**IN THE PUBLIC INQUIRY INTO THE COMPULSORY PURCHASE ORDER
FOR THE PROPOSED A650 HARD INGS ROAD IMPROVEMENT SCHEME
CITY OF BRADFORD METROPOLITAN DISTRICT COUNCIL**

OBJECTIONS

MR TARIQ GHAFOR

**CPO for Proposed A650 Hard Ings Road Improvement Scheme.
Land and Buildings Known As Hard Ings Motor Company.
Proprietor: Mr Tariq Ghafoor**

2.1.1 The proposed A650 Hard Ings Road Improvement Scheme has been promoted by the City of Bradford Metropolitan District (CBMDC). The following extract from A650 Hard Ings Road Improvement Scheme Engineering Feature Plan 3 prepared by CBMDC shows the effect of the scheme on the site.

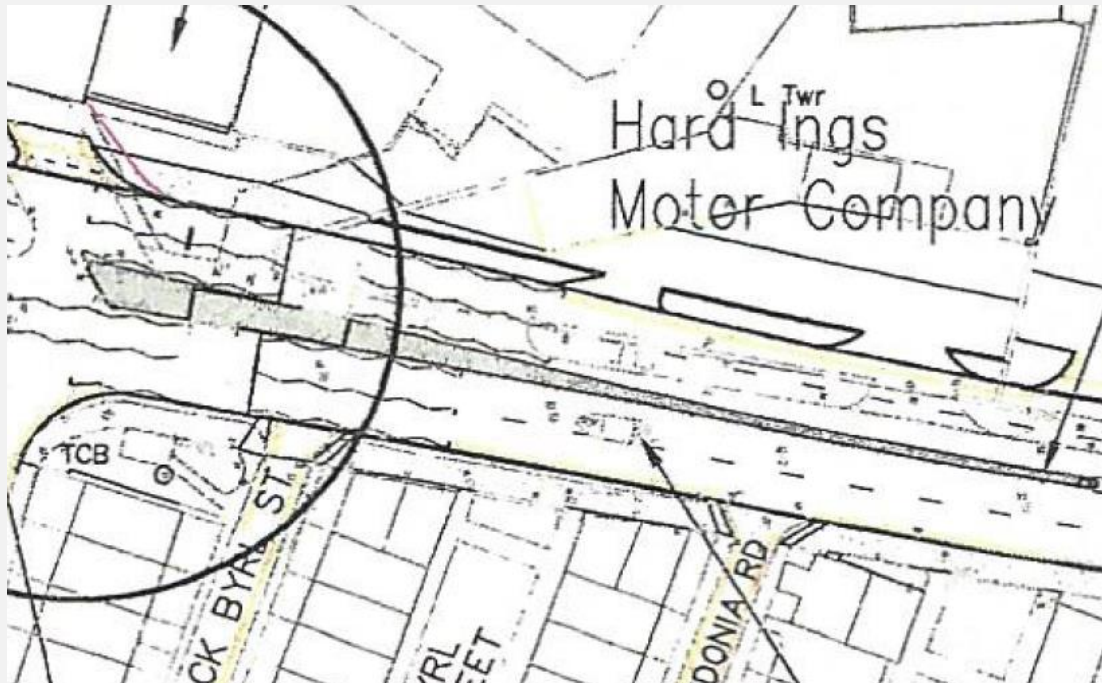
2.2.3 Part of the site is the subject of a CPO for the A650 Hard Ings Road Improvement Scheme as illustrated above. I understand that the road will be widened to provide a dual 2 lane carriageway and some of the land within the site will be required for the new highway. The scheme makes provision for a left turn vehicular access into the site and for a left turn vehicular exit from the site onto the proposed eastbound carriageway of Hard Ings Road. Following my representations and objections, the CBMDC has recently agreed to amend the proposals to make provision for right turning vehicular access into the site from the proposed westbound carriageway. However, the CBMDC have rejected my request for the provision of a facility for vehicular right turns out of the site onto the proposed westbound carriageway.

2.2.4 The CPO will affect the layout of the site including vehicular access, circulating traffic, parking facilities, servicing of buildings and the vehicular exit. Buildings currently on the site will have to be demolished and new buildings constructed at a location suitable for the revised layout of the site and the associated vehicular movements. The CBMDC have not offered any compensation for the costs of these and other associated works.

3.1.1 In my view, the loss of land from the site will have a significant effect on the financial value of this brown-field site and any returns arising from its redevelopment. The site is small and any reduction in area will severely restrict the redevelopment potential and the options available to me to maximise the returns from my investment. I have already sought advice concerning the financial value of the effects of the CPO on the reduction in potential returns from my investment and am not satisfied with the level of compensation that has been offered by the CBMDC.

3.1.2 The CBMDC has advised me that, as a result of the proposed highway scheme, part of the site will be compulsorily purchased for the construction of the new highway and footpath. I have also been advised by the CBMDC that the CPO will result in space restrictions within the site. The current vehicular access, vehicle circulation and parking arrangements, servicing of buildings and the layout and location of buildings on the site will be affected by the CPO. CBMDC have advised with several proposed site layout plan options, that these restrictions will necessitate a complete re-design of the layout of the site which will require the reconstruction of the access road, circulating area, parking areas, vehicle access for the servicing of buildings and the exit road.

3.1.3 In addition to the above vehicular restrictions, CBMDC have advised with several proposed site layout plan options, that the existing buildings on the site will have to be demolished and new buildings constructed at a location within the site suitable for the new road layout and parking arrangement. New supplies for the servicing of these new buildings will have to be provided as well as new foul and surface water drainage.

3.1.4 The retaining walls north and eastbound of the site will be affected by these reconstruction works and these walls will have to be removed and reinstated with suitable new retaining walls to accommodate the proposed new site buildings.
